National Committee on Uniform Traffic Control Devices

Item Number: 25B-RR-02

NCUTCD PROPOSAL FOR CHANGES TO THE MANUAL ON UNIFORM TRAFFIC CONTROL DEVICES

COMMITTEE / TASK FORCE: Railroad and Light Rail Transit Technical Committee
ITEM NUMBER: 25B-RR-02
TOPIC: LRT Signal Indications
ORIGIN OF REQUEST: RRLRT TC
**AFFECTED SECTIONS
OF MUTCD:** 8D.15, Figure 8D-3

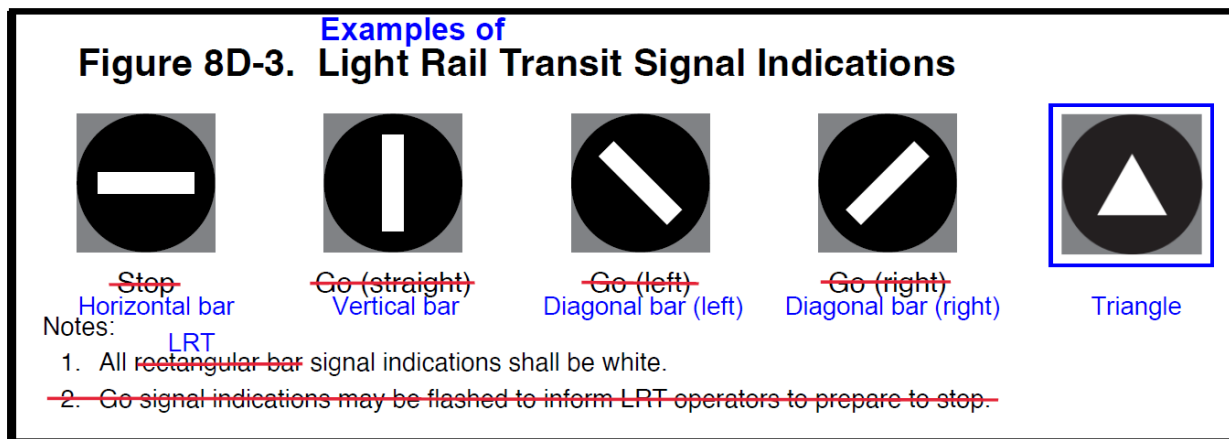
The important characteristic of an LRT signal indication is that it is easily distinguishable from the standard red/yellow/green traffic signal indications, so that its operation does not create confusion for other road users. This distinction is accomplished with white indications and the shapes of the indications, which are different than standard traffic signal indications. White transit signal indications using shapes not shown in 8D-3 would still provide this distinction and transit operators have been using white triangle indications as allowed in the previous editions of the MUTCD for years. Allowing additional shapes would provide transit operators more flexibility to indicate special movements or operations at a signalized intersection, and there is no known research indicating that the triangle indication caused road user confusion or other issues. The proposal adds an Option statement to Section 8D.15 to allow other shapes of white transit signal indications and modifies Figure 8D-3 to remove the reference to bar signals.

The text in Section 8D.15 does not contain the definition of the LRT signals or their operations, but a meaning for each indication is included in Figure 8D-3. However, the application of LRT signal indications and their meanings are not uniform across the transit industry. Each transit agency defines the meaning of the LRT signals used on their system in the agency's rules of operation and LRT operators are required to be trained in and follow the agency's operating rules. As a result, the same indication could be used to communicate "prepare to stop" or "prepare to go" or other operations within different transit agencies. The 11th Edition NPA Executive Summary explains that "uniformity and consistency in message, placement, and operation of traffic control devices have been shown to address the expectancy of the road user, resulting in a more predictable response." However, inconsistency in the shape, meaning, and operation of LRT signal indications does not cause issues for the road users because the LRT signal indications do not communicate any meaning to the road users. Further, LRT operators on one transit system do not need to recognize or respond to LRT signal indications on a different transit system. Consistency in the meaning of LRT signal indications across transit systems does not contribute to the safety or efficiency of the transit systems, and Figure 8D-3 does not recognize all the current meanings and operations of the LRT signal indications. Therefore, the meaning of each LRT signal is proposed to be eliminated from the figure to provide flexibility to transit agencies and permit the current LRT signal indications and operations, which do not negatively affect road users.

104 05 If a signal face used to control LRT movements cannot be positioned where the indications are not
105 visible to road users, the LRT signal indications shown in Figure 8D-3 should be used.

107 06 If special LRT signal indications such as those shown in Figure 8D-3 are used, the color of the
108 signal indications shall be white.

111 06a Other shapes or symbols that could not be confused with standard traffic signal indications may be
112 used for LRT signal indications.
